Products Change Notification

PCN # 84087

656 Series wire leads versions, see affected part numbers for full list

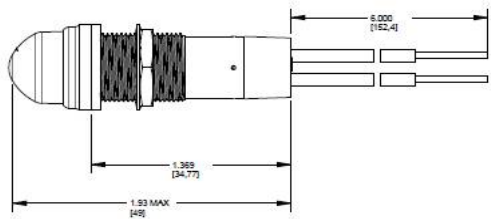
Modification to the end of the insert making the solid part 0.170" longer

Old Part (Before Inset Modification)

New Part (After Inset Modification)
